**TOWN OF WILLISTON  
DEVELOPMENT REVIEW BOARD  
November 26, 2024, 7:00 PM  
Town Hall Meeting Room | 7900 Williston Road**

**DP 25-04 Pre-app** Charlotte Isham Marcotte Revocable Trust c/o John Marcotte requests pre-application review of proposed 9-lot open space subdivision (8 dwelling lots, 1 open space lot) on

DP 24-09 Gregory, Anna, and Laura Benedetto c/o Doug Goulette requests discretionary permit review of a proposed open space 6-lot subdivision on an existing 10.76-acre parcel to create three (3) dwelling lots (1.53, 0.46, and 0.7 acres) and three (3) open space lots (4.39, 1.37, and 2.31) at 1318 Butternut Road in the Agricultural/Rural Zoning District (ARZD).

DP 25-03 LNP Inc c/o O'Leary-Burke Civil Associates requests discretionary permit review to amend final plans SP-07-12 with an outdoor storage area at 378 Commerce Street in the Industrial West Zoning District (IZDW).

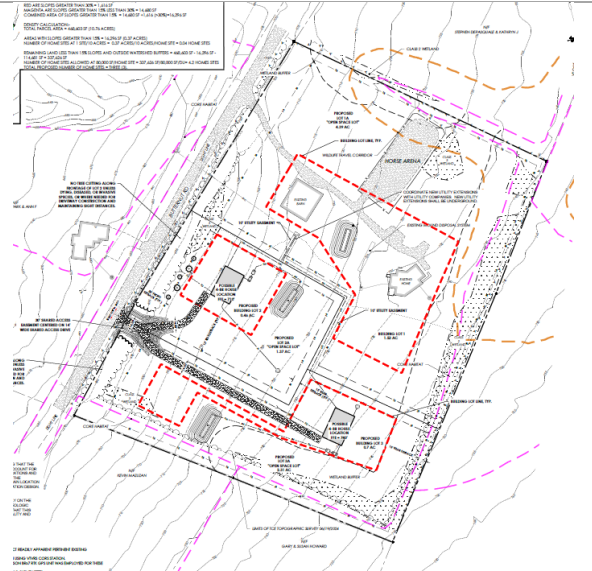
**31.3.2 Setbacks from property lines – Compliance anticipated. Final plans shall identify 15’ side and rear setbacks on each house lot.** Though the bylaw does not have a parcel configuration requirement, the layout of Lot 3 is concerning. The long, narrow strip is ~15’ wide and thus cannot accommodate any structure due to setbacks. The square area closer to Butternut Road is approx. 85x85’ which yields a 55x55’ building envelope. The applicant and future owners should be aware of the limitations this lot layout will have for house placement, additions, and accessory structures.

**31.3.6 Lot Dimensions – The plat and site plans must be revised to designate a 40’ private driveway easement from Butternut Road to each house lot.** The open space lots meet the frontage requirement along Butternut Road. Even if open space lots are conveyed with a house lot, the house lots need frontage on a 40-ft wide “road or drive.” Lot 1 needs a 40’ access easement over Lot 1A. The plat identifies a 30’ easement extending into Lot 2A and 3A, but it does not extend to Lots 2 and 3. As proposed, Lots 2 and 3 do not have frontage on a public or private road or driveway.

**Open Space, Configuration & Contiguity** – Condition #3b necessitates a revision to the layout, a layout that was otherwise acceptable at pre-application prior to the open space requirement. The WCC Finding #4 concluded, “The proposed open space is not contiguous” but that it could “be approved under Williston’s development standards for open space subdivisions” if the applicant revises the site plan in accordance with Condition #3b. WDB 31.7.2 lists 7 resources that must be included in open space: 4 are not applicable, 2 already protected by the layout (SWHA and watershed buffers), and 1 category remains: “31.7.2.7 Other Lands.” The open space is contiguous with open space on adjoining properties to east and south. The bylaw gives the DRB and WCC discretion in determining the configuration of open space, but WDB 31.7.3 requires that open space be contiguous. The bylaw does not provide further guidance in 31.7 for what “contiguous open space” looks like, especially in areas that are not specifically mapped for habitat protection, wetlands, important farmland, or steep slopes.

- 20. The plat and site plans must be revised to designate a 40' private driveway easement from Butternut Road to each house lot.**
- 21. The statement "no tree cutting along frontage of Lot 2/2A and 3/3A unless dying, diseased, or invasive species or where needed for driveway construction and maintaining sight distances" shall be revised to add "and gaps created by removed vegetation shall be replanted in order to maintain effective screening, but not invisible, per WDB 31.9.6"**

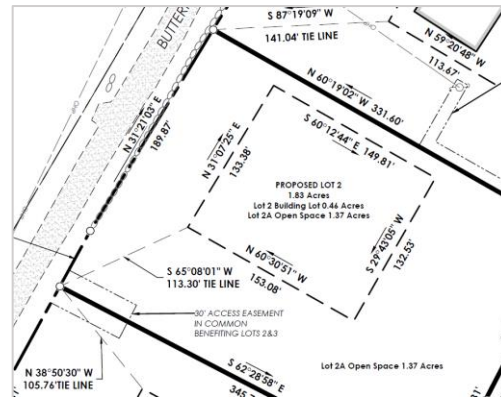
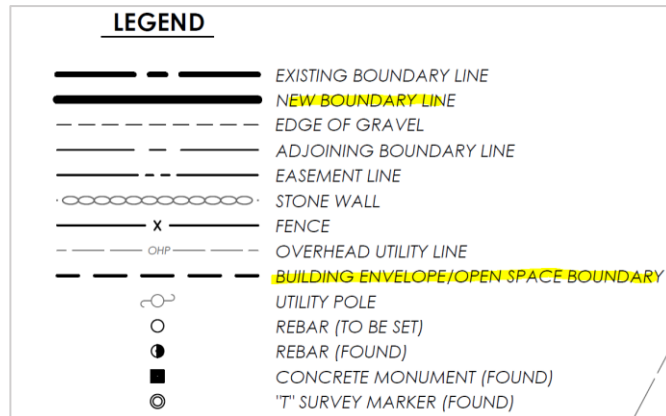
At Final Plans, the plat must be revised. Per WDB 31.7.7, open space must be platted separately. Per 31.7.8, “...open space ...must be monumented in accordance with the requirements of 12.4.1.5 with the same degree of accuracy as a building lot.” For parcels larger than 10.5 acres, open space cannot be designated with a building envelope and open space area within the same lot. The narrative letter describes a 3-lot subdivision where the applicant is intending to create 6-lots. The plat needs to be revised to eliminate the ‘building envelope/open space boundary’ designation and show all proposed boundaries as ‘new boundary line.’ The plat must be revised to include survey monuments for the house lots same as the open space lots in conformance with WDB 12.4.1.
